Memorandum

To: Bassett Creek Watershed Management Commission (BCWMC)
From: Barr Engineering Co.
Subject: Item 5B. Consider Approval of Feasibility Study and Choose Concept to Implement for Medley Park Stormwater Treatment Facility Project, Golden Valley (CIP 2022 ML-12) - BCWMC June 17, 2021 Meeting Agenda
Date: June 10, 2021
Project: 23270051.51

5B Consider Approval of Feasibility Study and Choose Concept to Implement for Medley Park Stormwater Treatment Facility Project, Golden Valley (CIP 2022 ML-12)

Medley Park Stormwater Treatment Facility Feasibility Study

FIGURE 2-1

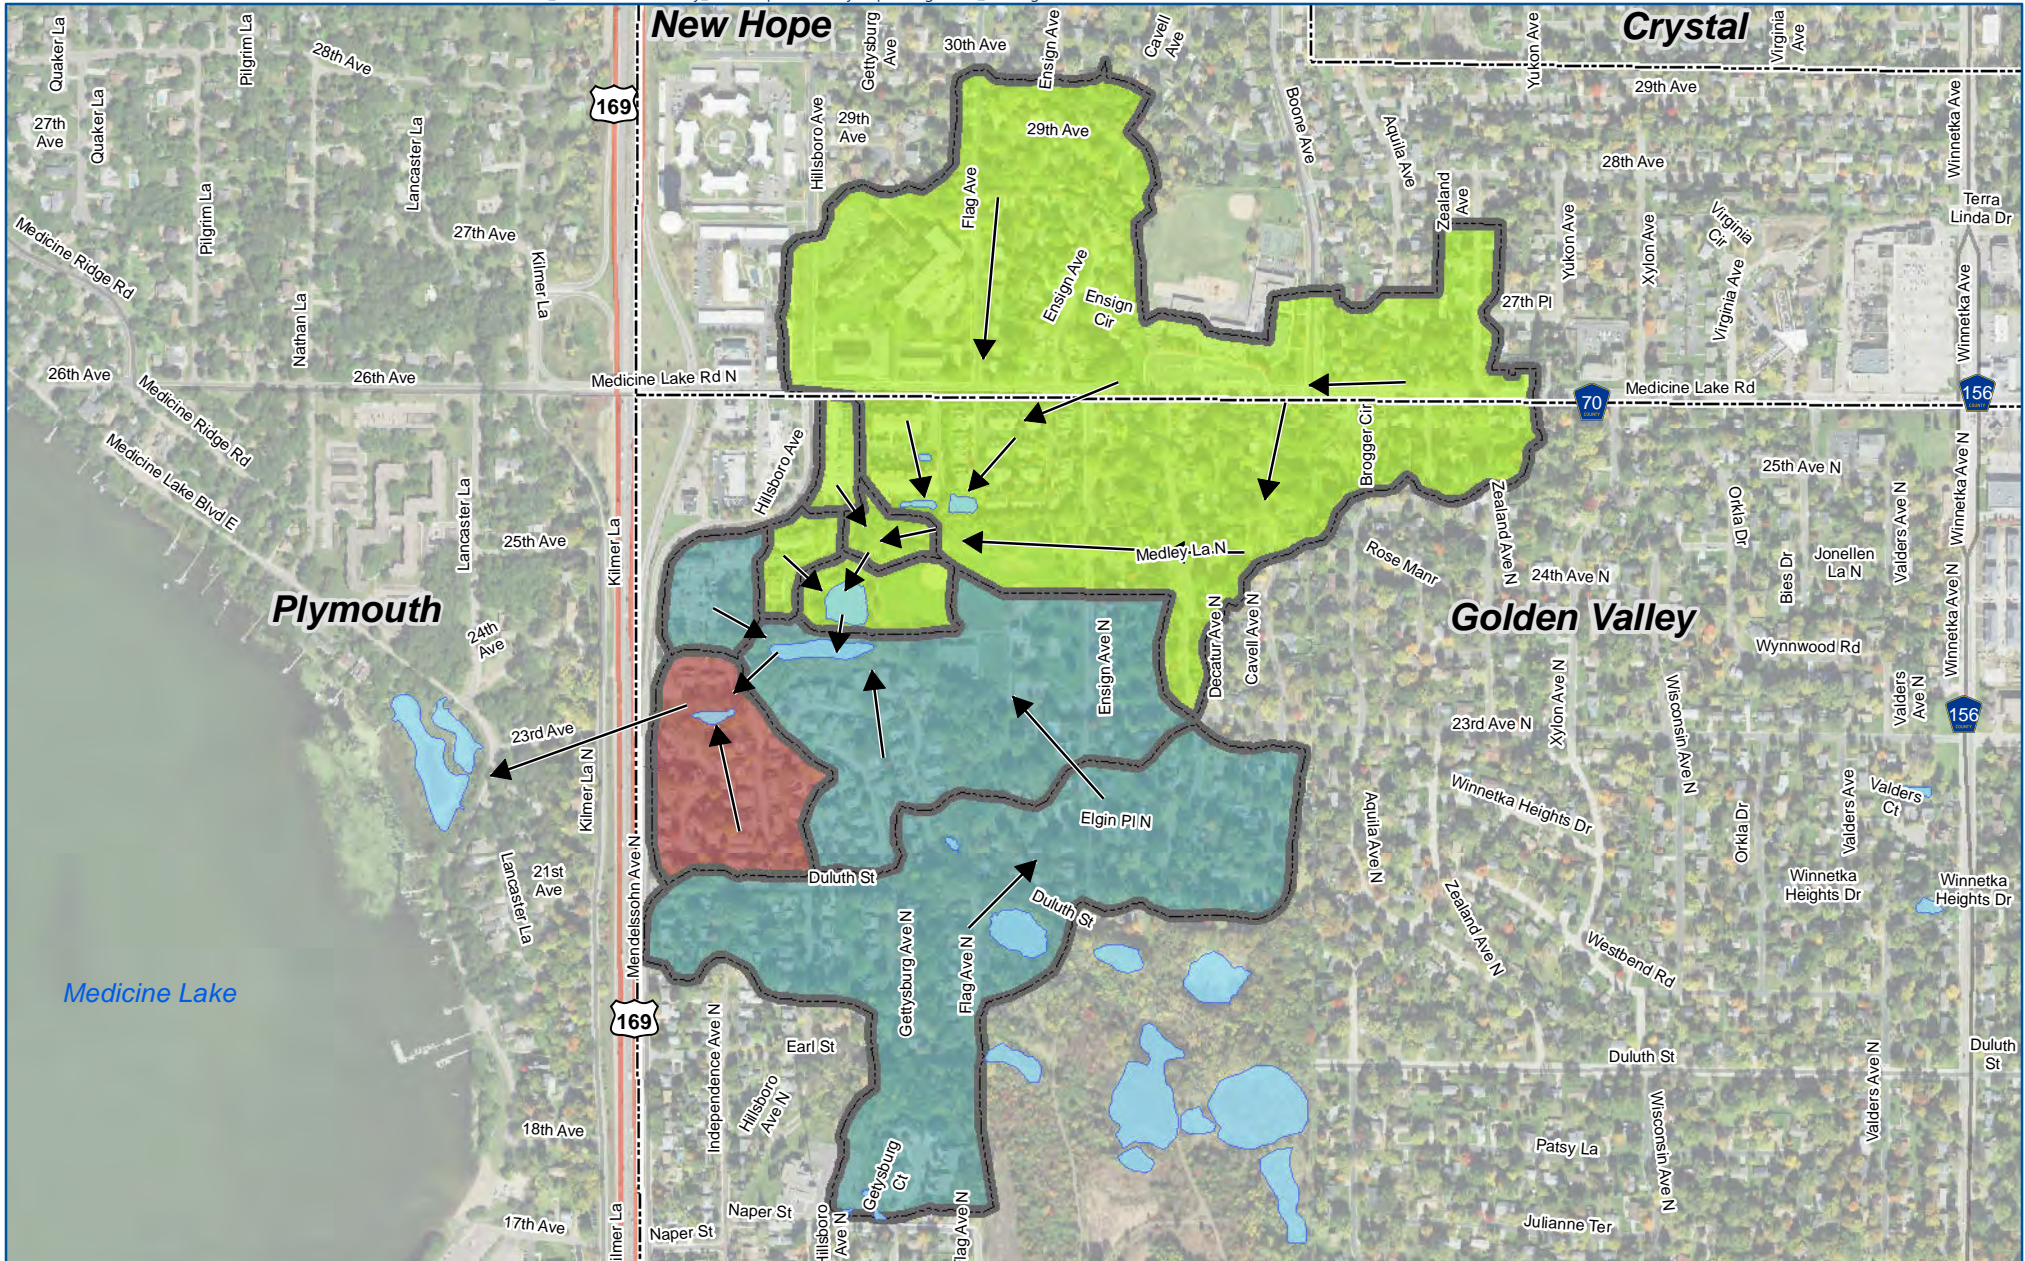
3. Figure 2-1 – Project Area
 - a. Flow arrows were added to the stormwater channels, Medley Pond outlet, and Kings Valley Pond outlet to clarify stormwater flow directions.

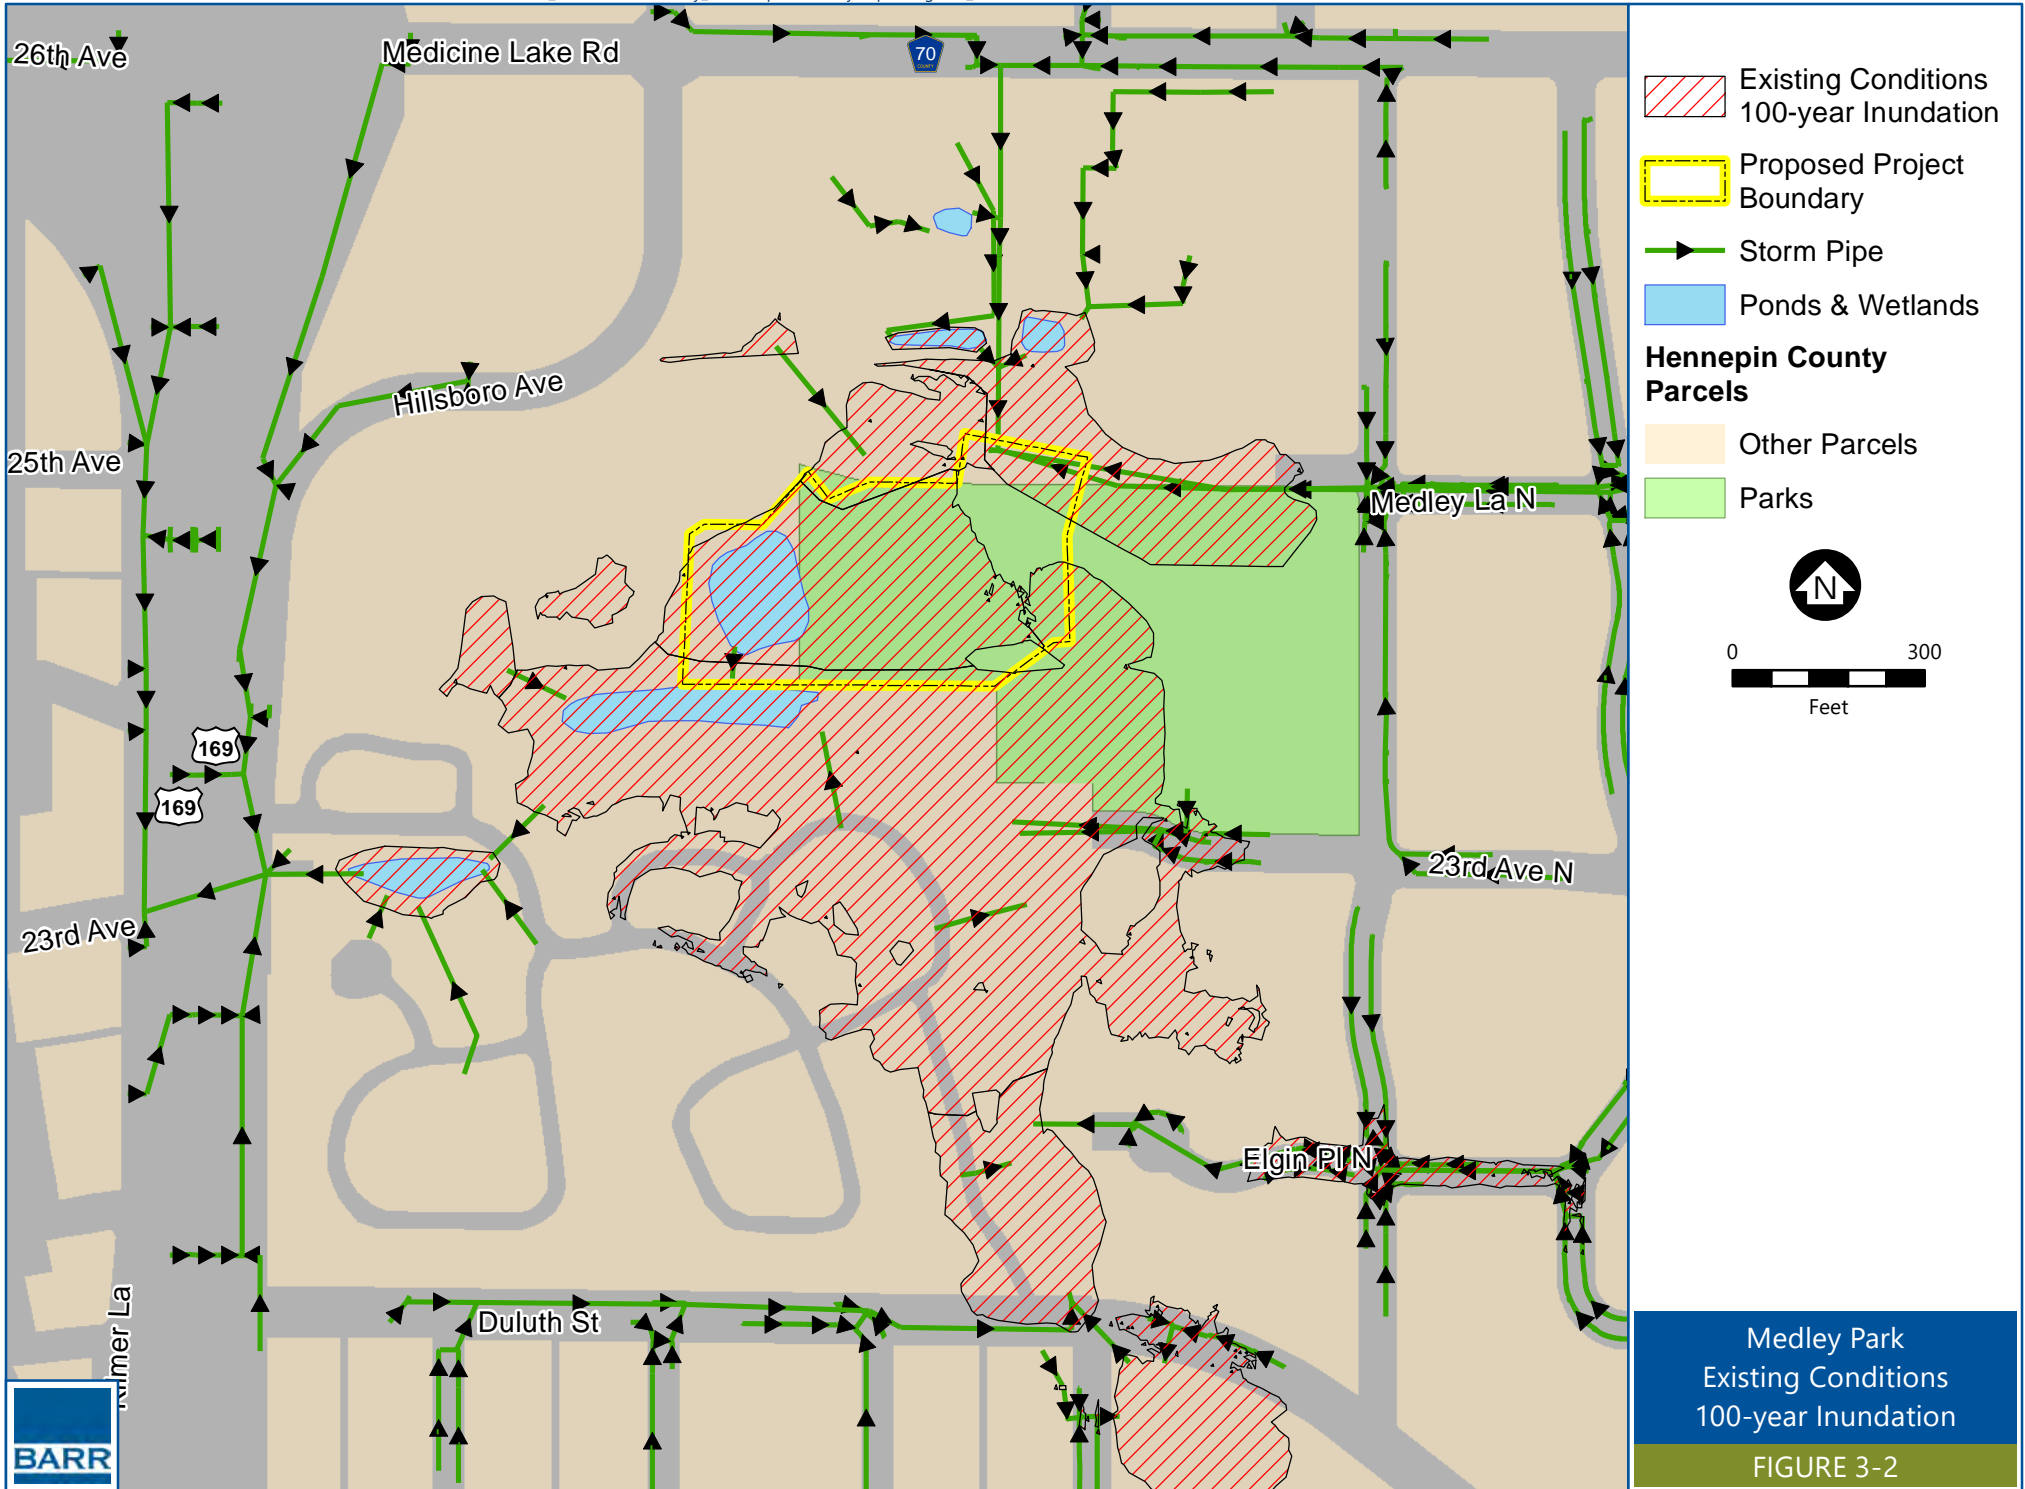
4. Figure 3-2 – Existing Conditions 100-year Inundation
 - a. This is a new figure which shows the existing conditions Atlas-14 100-year 24-hour design storm event inundation extents to provide context for flooding concerns. Structure locations or aerial imagery was not used for homeowner confidentiality concerns.

- b. A figure showing the proposed conditions Atlas-14 100-year 24-hour inundation extents was not developed. The drop in the 100-year maximum water surface elevations were not great enough to show a significant change in the LiDAR-produce inundation area. It was determined that Table 6-3 provided a better representation of the impacts to at-risk flood structures.

FIGURE 3-4

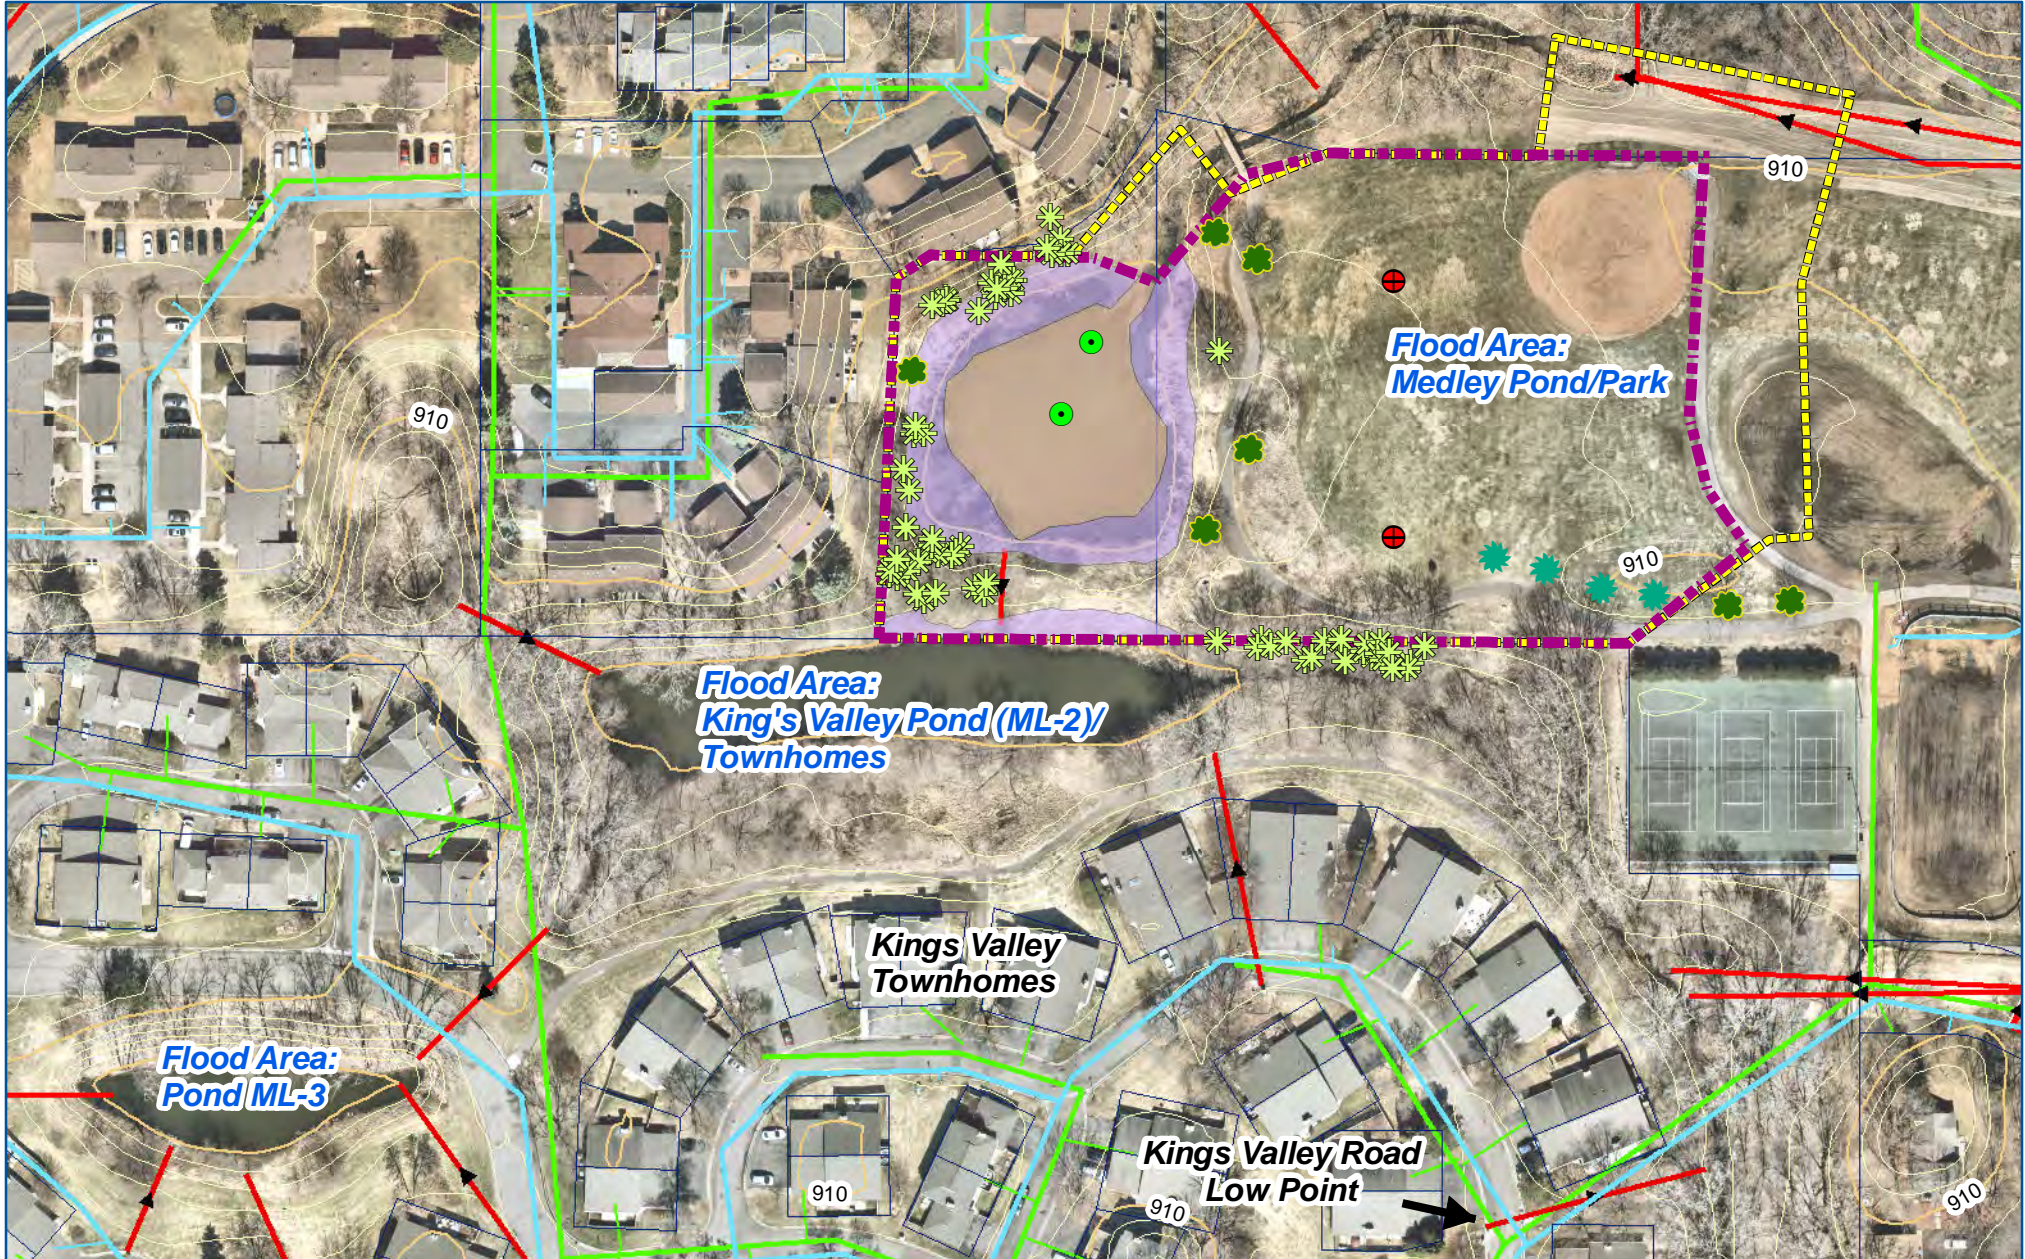
5. Figure 3-4 – Site Conditions
 - a. The wetland survey boundary was added to Figure 3-4.
6. Section 5.0 – Potential Improvements
 - a. For discussions related to proposed increases to flood mitigation volumes, in-text clarification was added throughout the section confirming that increases in flood mitigation volumes are “up to the 100-year flood elevation.”
